Subject ▶ Change on Impact Bolt, Tool Holder and addition of Cap

For Models ▶ HR3850B,HR3850,HR3851(Rotary Hammer Drills)

► Current

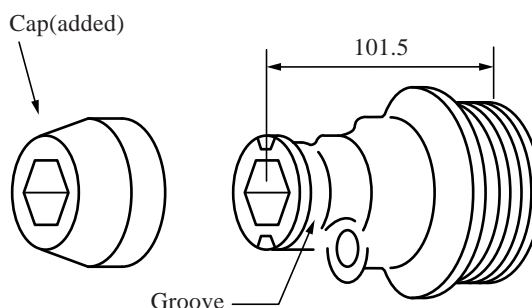
Description ▶ As illustrated below, Impact Bolt and Tool Holder have been changed for improvement in endurance. Cap has been added as dust cover.

Tool Holder

Impact Bolt

Item No.	Current part		Q'ty	I/C	New part		Q'ty	Note
51	Impact Part 322218-6		1	No	Impact Bolt 323718-9		1	Interchangeable as a set
58	Tool Holder 322221-7		1	No	Tool Holder 323717-1		1	
117					Cap 421596-2		1
